Exhibit A – Environmental Determination Appeals

THE UNDERSIGNED RESPECTFULLY REQUESTS AN APPEAL FOR THE FOLLOWING ENVIRONMENTAL DETERMINATION: File No. PD19-031: Initial Study - Mitigated Negative Declaration

for Aviso Hotel Project North 1st Street - Nortech Court

**Re: Alviso Hotel Project (File No. PD19-031)
LIUNA Supplemental Comment- Mitigated Negative Declaration
DIRECTOR HEARING AGENDA ITEM 4.a (April 6, 2022)**

Figure 1. Actual and predicted relationships between the number of vertebrate wildlife species detected and the elapsed survey time based on visual scans on 30 October 2021 (blue) and on 1 April 2022 (red) at the project site.

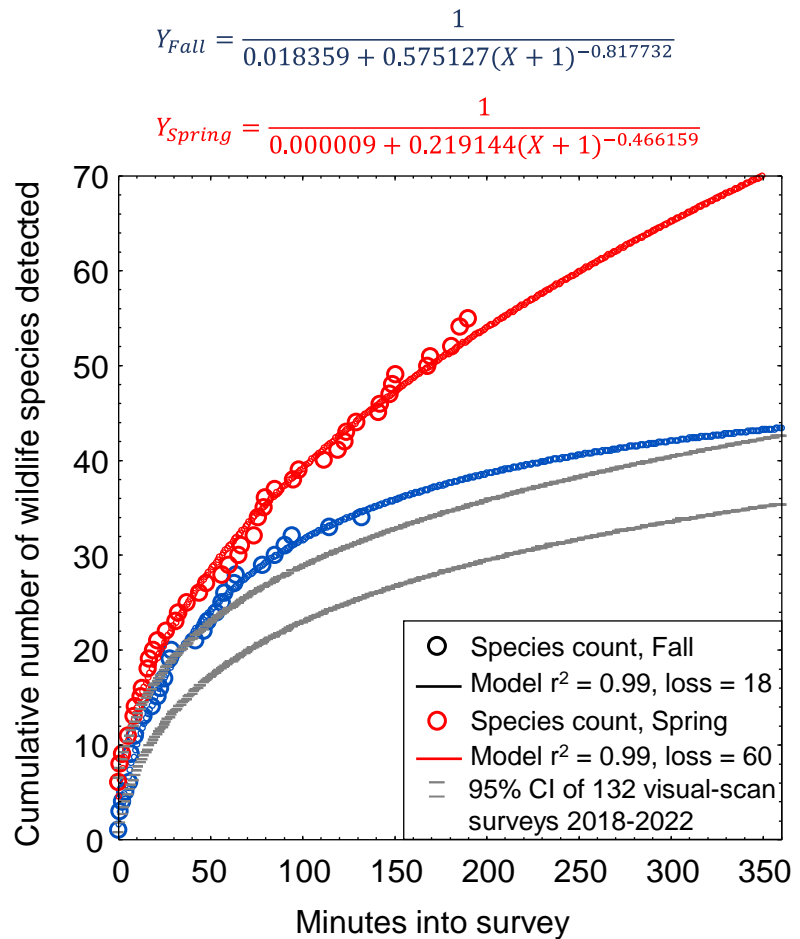
With another survey completed, the projection of species richness I made from the pattern of the data on 30 October 2021 can be compared to another projection from the pattern of the data on 1 April 2022. Figure 1 depicts the patterns of increase in cumulative species richness with time into the survey for both the October and April surveys, and it further compares them to the 95% confidence interval of the increase in mean cumulative species richness across another 132 surveys I completed at proposed project sites across California over the last several years. Whereas the pattern observed in October trended along the upper bound of the 95% CI, and for a time even exceeding it, the pattern observed in April far exceeded the upper bound of the 95% CI from start to finish (and beyond). Whereas the model fit to the data from 30 October predicted 54 species of wildlife could have been detected that day, the model fit to the data from 1 April indicated that I spent insufficient time at the site for the model to estimate a realistic asymptote. In other words, I could not predict the total number of species I likely would have detected had I committed more survey time to 1 April. I am confident, however, that the predicted number would have far exceeded the 55 species I detected.

Figure 2. Mean (95% CI) predicted wildlife species richness, \hat{R} , as a nonlinear function of hour-long survey increments across 46 visual-scan survey stations across the Altamont Pass Wind Resource Area, Alameda and Contra Costa Counties, 2015–2019.

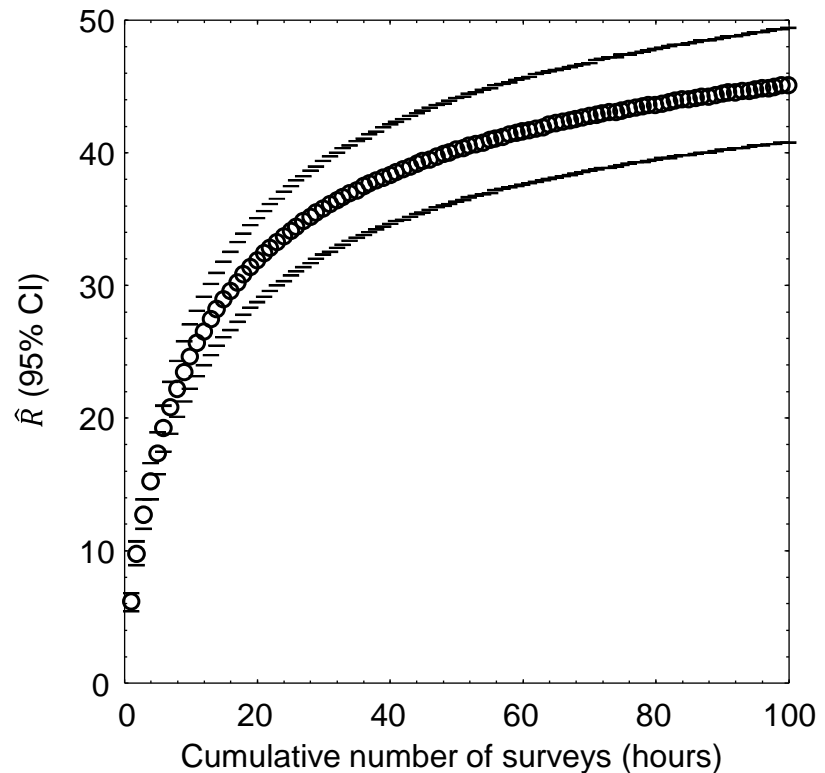
The mean model-predicted asymptote of species richness was 57 after 11,857 hours of visual-scan surveys among the 46 stations. Mean model predictions of species richness at each incremental increase of number of surveys, i.e., number of hours, is shown in Figure 2. Via an analytical bridge, these mean model predictions can add inference from longer-term survey efforts at other sites to the outcomes of my brief reconnaissance-level surveys at the project site, thereby enabling empirically-founded estimates of the number of vertebrate species using the site over the longer-term, say a year to several years.

Relevant to my first survey at the project site on 30 October 2021, on average I detected 9.6 species over the first 1.96 hours of surveys in the Altamont Pass (1.96 hours to match the number of hours I surveyed at the project site), which composed 16.8% of the total predicted species I would detect with a much larger survey effort. Given the example illustrated in Figure 2, the 34 species I detected after my 1.96 hours of survey at the project site likely represented 16.8% of the species to be detected after many more visual-scan surveys over another year or longer. With many more repeat surveys through the year, I would likely detect $34 / 0.168 = 202$ species of vertebrate wildlife at the site.

Relevant to my second survey at the project site on 1 April 2022, on average I detected 13.3 species over the first 3.25 hours of surveys in the Altamont Pass (3.25 hours to match the number of hours I surveyed at the project site), which composed 23.3% of the total predicted species I would detect with a much larger survey effort. Given the example illustrated in Figure 2, the 55 species I detected after my 3.25 hours of survey at the project site likely represented 23.3% of the species to be detected after many more

Photo 29. The TopGolf net viewed towards the glow of the rising sun at 06:42 hours, 1 April 2022. Note that the net would be less visible when viewed from the north or east. Also note that the guy cables are unmarked, and no markers are on the net.

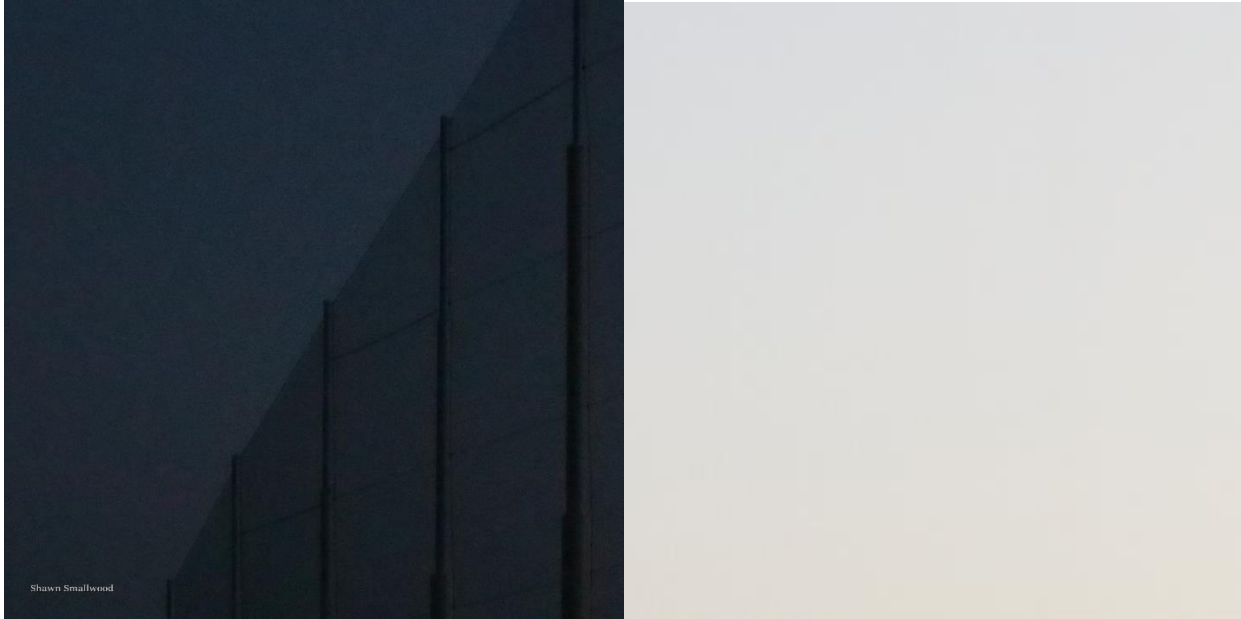
According to the response, the net is very obviously visible even from a distance and is therefore readily detectable by birds. The response is truer in the daytime than at night, which is when many birds fly. Even as late as 2 minutes before sunrise, the net is much less visible (Photo 29), but before this time the net was nearly completely invisible. I did not try photographing it earlier because it was too dark to see the net. Furthermore, the guy cables are unmarked, and no markers have been placed on the net (Photo 29), even though the Harvey & Associates (2016:43) reported they would be marked and even though I commented on 6 November 2021 that the net remained unmarked. Viewed northward against the darker sky (Photo 30), or viewed eastward through the net (Photo 31), the net is much harder to see.

My larger point is that this type of impact was not considered by City of San Jose, just as the City is refusing to consider the interaction effects I warn of between the net and the hotel building planned only 23 m away. Even now, birds are flying along the very corridor I pointed out in my comment letter of 6 November 2021. The killdeer in Photo 1 repeatedly flew parallel to the net and close to the net's unmarked guy cables, and Canada geese repeatedly flew the same path, one chasing the other per their social drama and therefore distracted from the threat posed by the net and its guy cables (see Photo 15). The current environmental setting is already hazardous to flying birds that must fly amid an unmarked 170-foot-tall net and its unmarked guy cables a very short distance to the north, and unmarked transmission lines to the south. The hotel, with its expansive windows, would add significantly to the collision risk faced by birds.

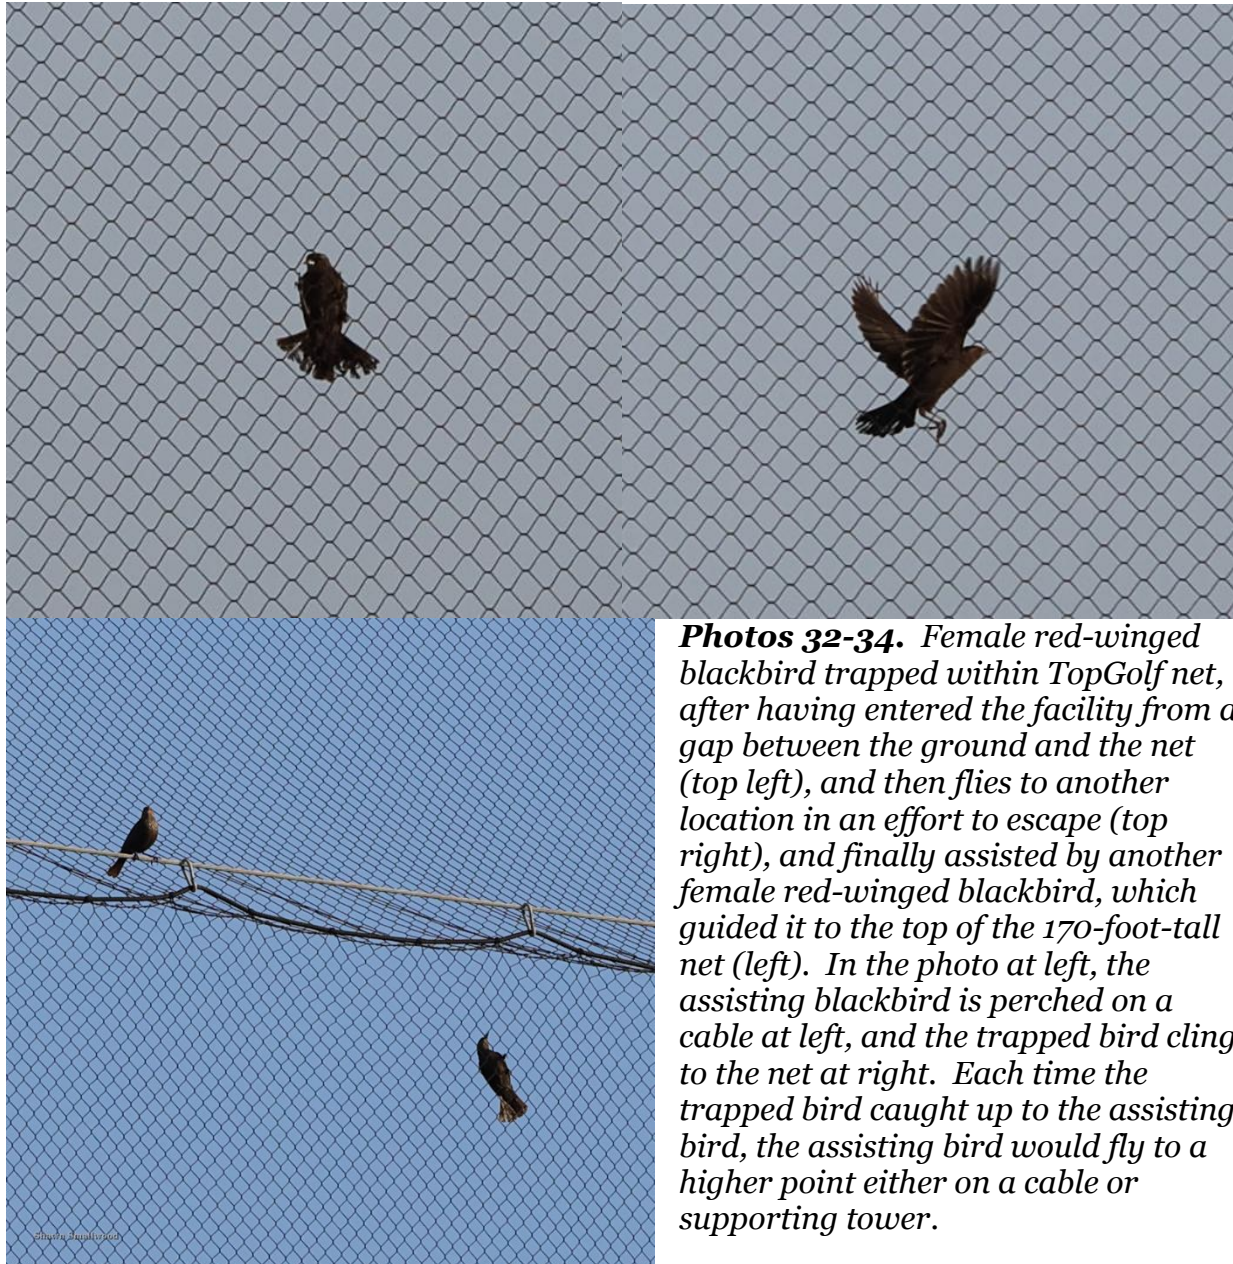
Reply: The proposed BMPs would not mitigate the major impacts of the project that I addressed in my comment letter of 6 November 2021. They would do nothing to avoid, minimize, reduce or compensate for impacts to wildlife caused by habitat loss,

interference with wildlife movement, and collision mortality with project-generated traffic and the hotel's windows.

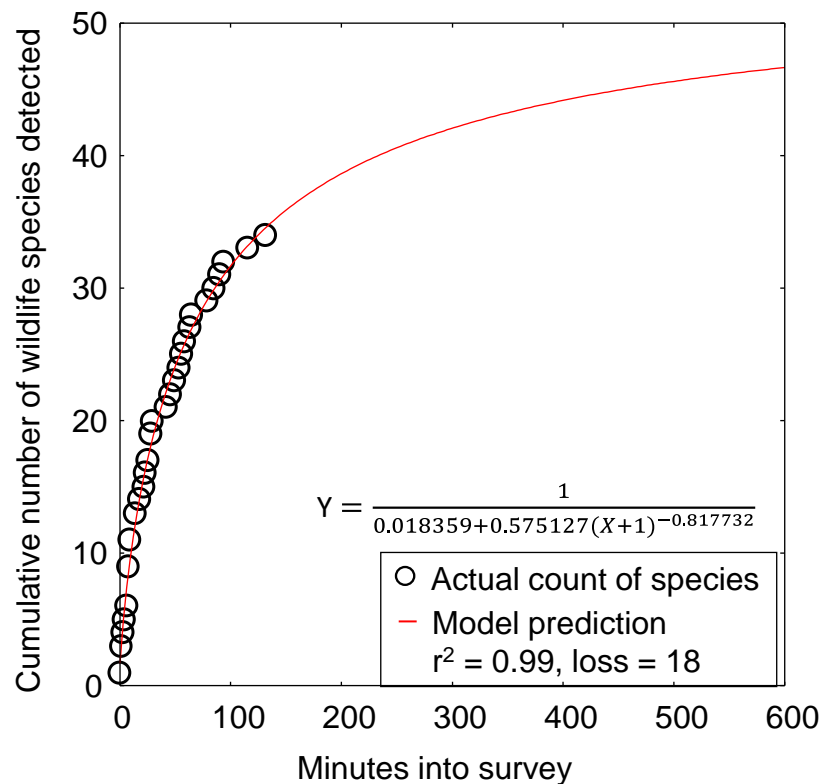
By recording when I detected each species, I was able to forecast the number of species likely to be detected with a longer effort using the same visual scan method. Figure 1 shows my cumulative counts of species detected with increasing time into both of my surveys. Just as I have seen for many other survey efforts, a nonlinear regression model fit the data very well, explaining 99% of the variation in the data, and the model showed progress towards the inevitable asymptote of the number of species detectable over a longer time period using the same survey method. In the case of this project site, my model predicted I would have eventually detected another 20 species, or 54 species of vertebrate wildlife in total, had I continued the survey using the same method on 30 October 2021.

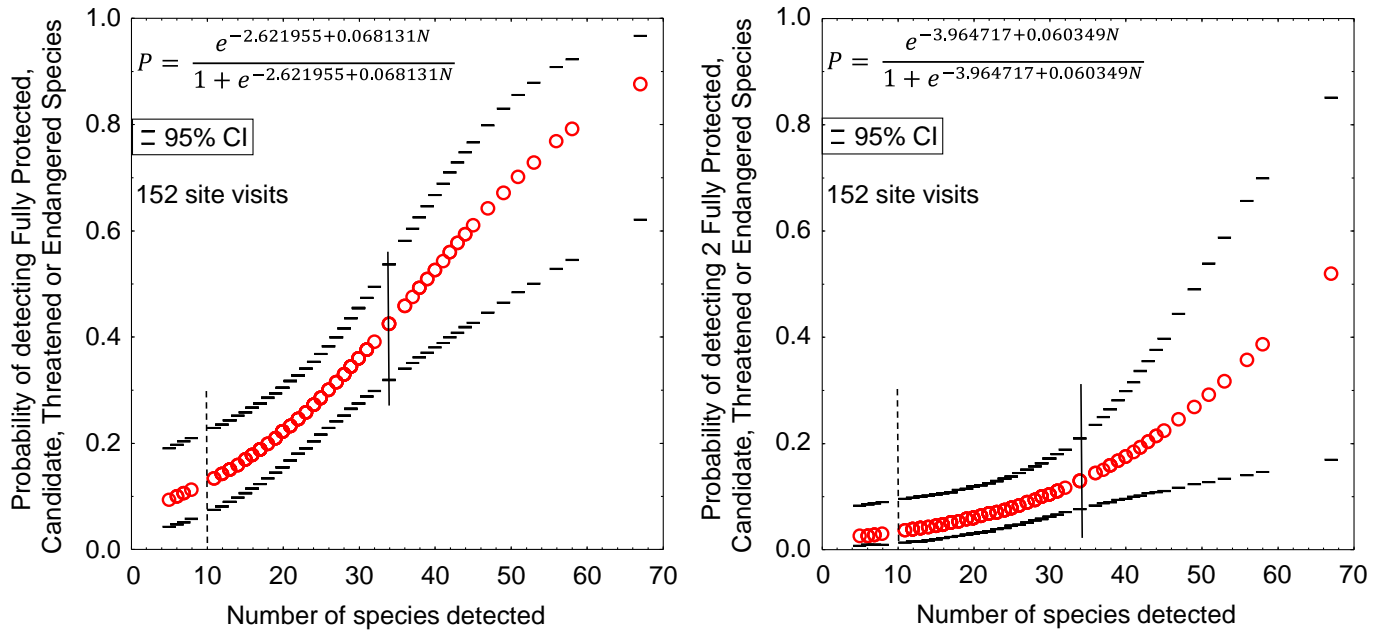
The likelihood of detecting special-status species is typically lower than that of more common species. This difference can be explained by rarity of special-status species, which also tend to be more cryptic, fossorial, or active during nocturnal periods when reconnaissance surveys are not performed. Another useful relationship from careful recording of species detections and subsequent comparative analysis is the probability of detection of listed species as a function of an increasing number of vertebrate wildlife species detected (Figure 2). (Note that listed species number fewer than special-status species, which are inclusive of listed species.) As had been demonstrated in Figure 1, the number of species detected is largely a function of survey effort. Therefore, greater survey effort increases the likelihood that listed species will be detected (which is the first tenet of detection surveys for special-status species). Based on the outcomes of 152 previous surveys that I performed at sites of proposed projects, my survey effort at the project site carried a 43% chance of detecting a listed species and a 13% chance of detecting 2 listed species (Figure 2). As it turned out, I detected 2 listed species (California brown pelican and white-tailed kite) this time, although both were just outside the project boundary. WRA (2020) Detected 10 species of vertebrate wildlife, so their survey effort carried only a 12.5% chance of detecting a listed species and a 3% chance of detecting 2 listed species.
